**THE SECOND MEETING OF THE APANPIRG AERODROMES
OPERATIONS AND PLANNING – WORKING GROUP (AOP/WG/2)**

Agenda Item 4: Provision of AOP in the Asia/Pacific Region
**HELIPORT SAFETY AREAS – INCONSISTENCIES IN
ANNEX 14 VOLUME II HELIPORT STANDARDS**

(Presented by Indonesia)

Figure 3-1. FATO and associated safety area

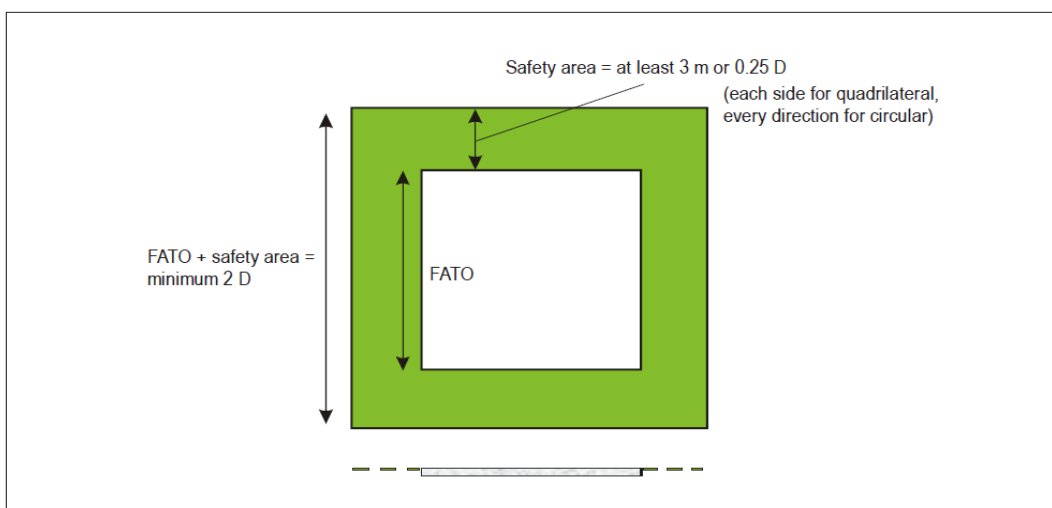
2.6 The standard dimension for safety areas whether at surface level heliport or elevated heliport if described together with FATO dimension as per figure below. FATO is D plus safety areas 0.25D at each side, total for safety areas should be 1.5D (D+0.25D+0.25D), not 2D. It seems there is inconsistency for dimension of safety areas at surface level heliport and elevated heliport.

3.1 The Meeting is invited to note the inconsistencies and invite ICAO to review the Annex 14, Volume II standards (Paras 3.1.22 and 3.2.21) for safety areas at surface level heliport and elevated heliport.
